SAFETY EVALUATION BY THE OFFICE OF NUCLEAR REACTOR REGULATION

SUPPORTING APPROVAL OF CRANE MODIFICATIONS AND USE OF

70 TON SPENT FUEL SHIPPING CASK IF-300

MONTICELLO NUCLEAR GENERATING PLANT

FIGURE 3-1

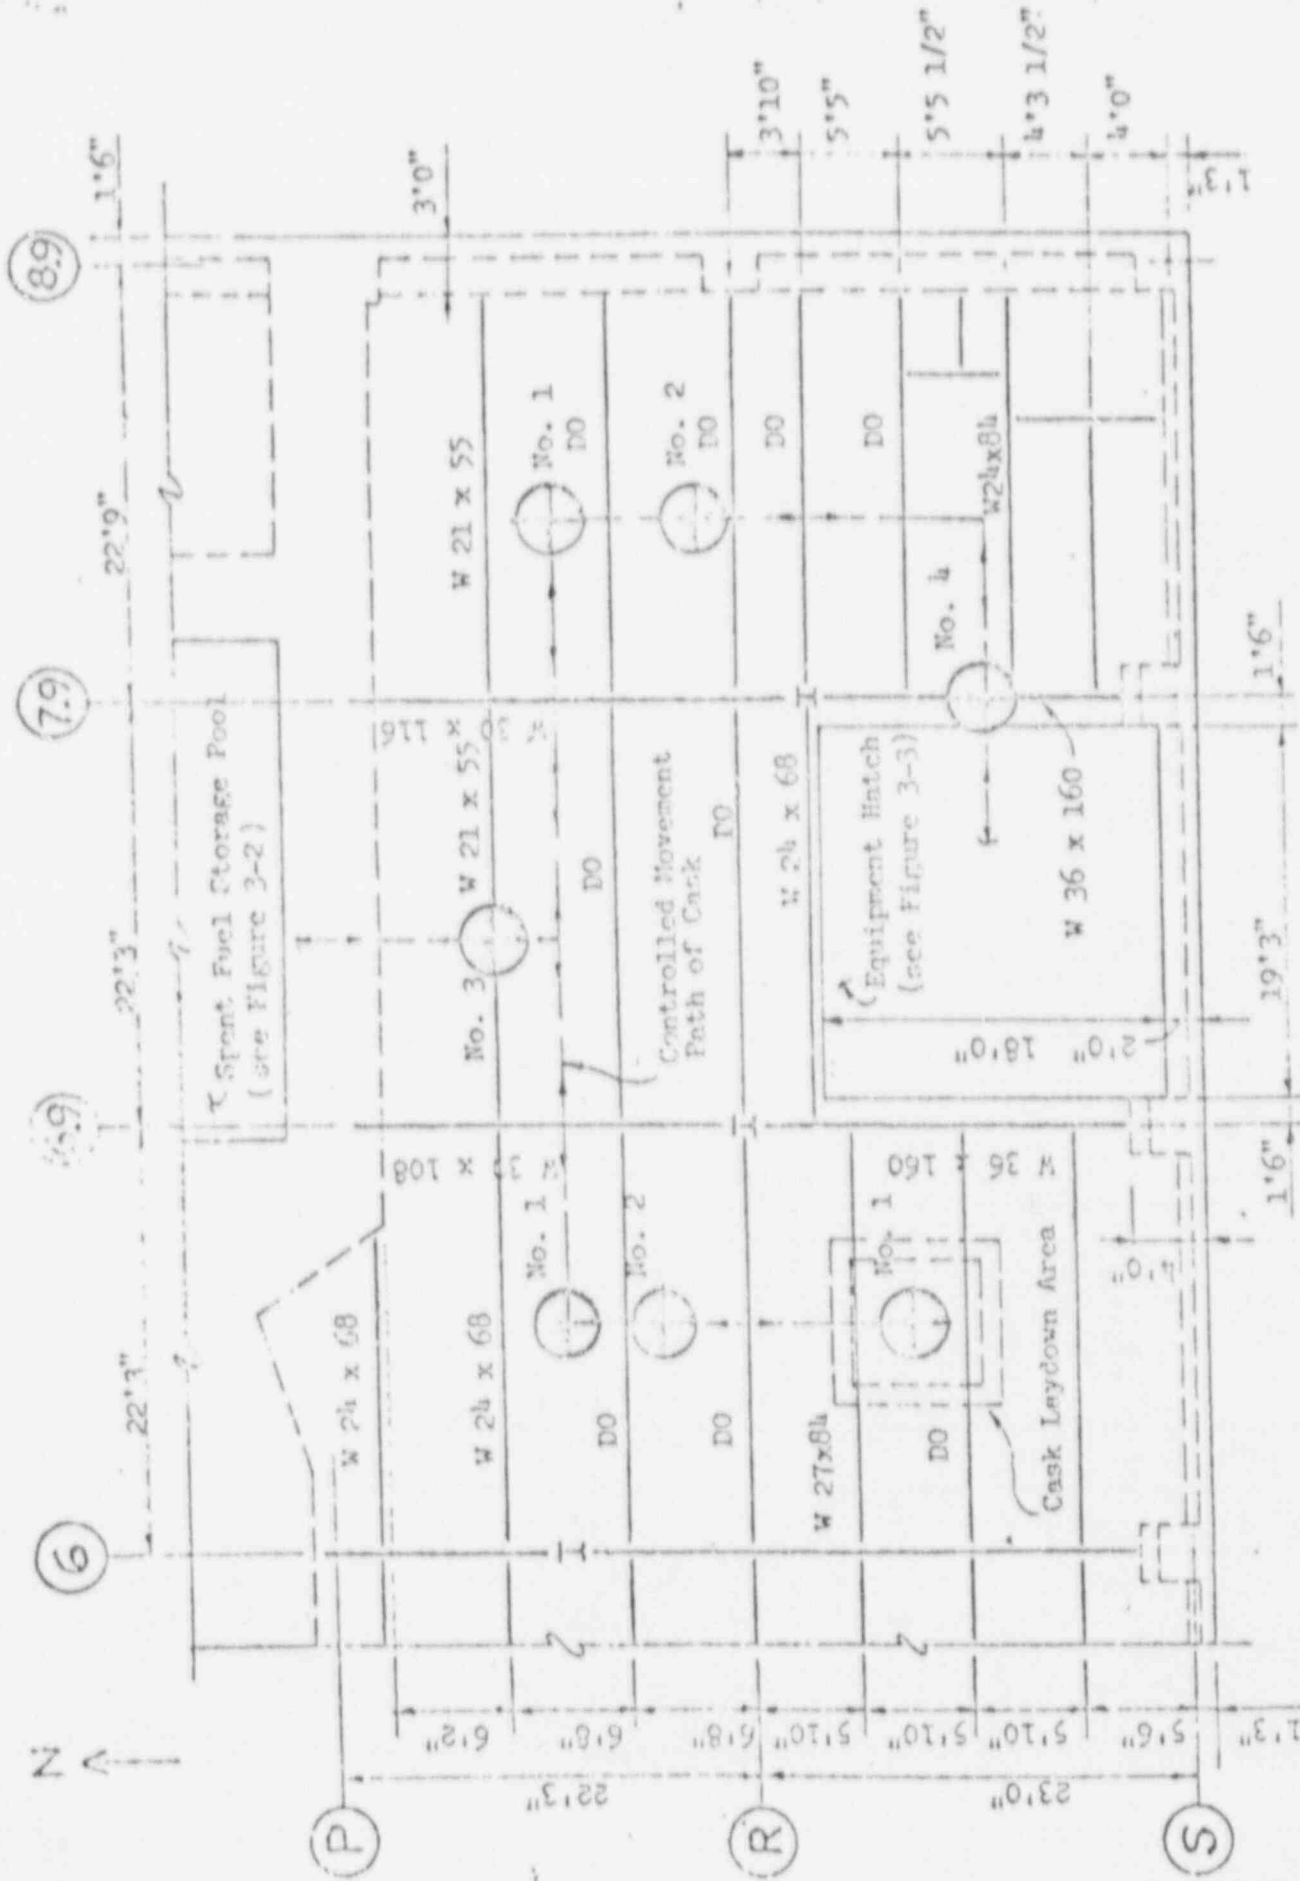
An analysis previously submitted by NSP indicates that the plant's structures are not capable of withstanding the drop of a 70 ton shipping cask. However, the interim program for offsite shipment of spent fuel was limited to the use of a 25-ton cask. The travel path of the cask between the transporter, laydown area, and the spent fuel pool cask loading area was established by the licensee. This travel path passes over those portions of the structure most capable of withstanding a cask drop accident. If the carrying height of the cask above the operating floor does not exceed six inches, the structures are capable of withstanding the drop of a 25-ton cask as indicated by NSP analyses. Figure 3-1 (attached) shows the travel path of the cask in relation to the supporting members below the operating floor.
